Meeting Date: June 20, 2011
Agenda Item: 8-9

**VILLAGE OF HOWARD PLAN COMMISSION
 STAFF REPORT**

REPORT SUBJECT: Action on the Final Planned Development District application to allow for the construction of a Menards retail store on the 29/42 Retail Centre Plat. Lots 35, 36, 37, 38, 39, and part of Lot 34 of the 29/42 Retail Centre Plat (VH-2039, VH-2040, VH-2041, VH-2042, VH-2043, VH-2044 – approximately 18.69 acres north of Woodman Drive across from Gander Mountain.)

Howard, Wisconsin
 April 22, 2011
 Proposed Site Photometrics Plan
 Scale: 1" = 60'-0"
 CT6

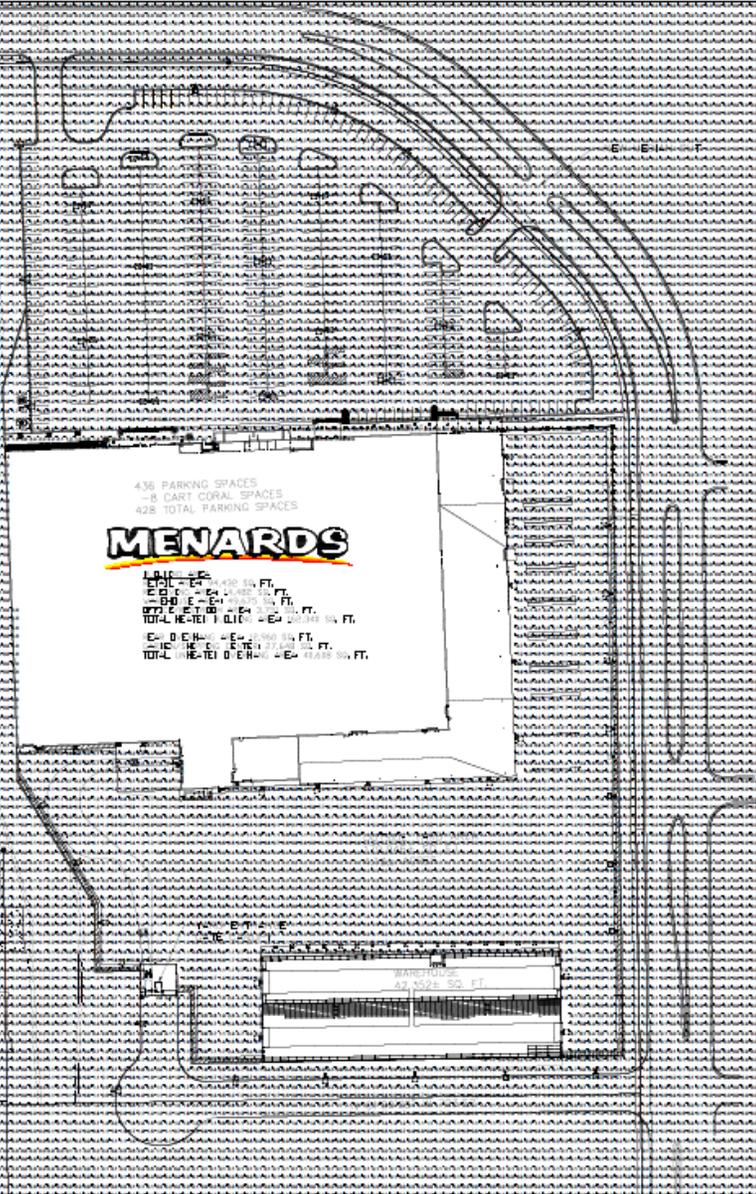
Under the B-1 regulations, the overall height of light fixtures installed to illuminate parking lots and exterior grounds shall not exceed 30 feet or the height of the principal structure, whichever is less. The proposed lighting needs to be consistent with the height of the proposed principal structure.

3. The developer pays all costs for design and construction of traffic improvements associated with the project.
4. The photometric plans for the site be modified to 30 feet or the height of the principle structure, whichever is less within the parking areas and the color of the parking lot lights match the existing street lights.
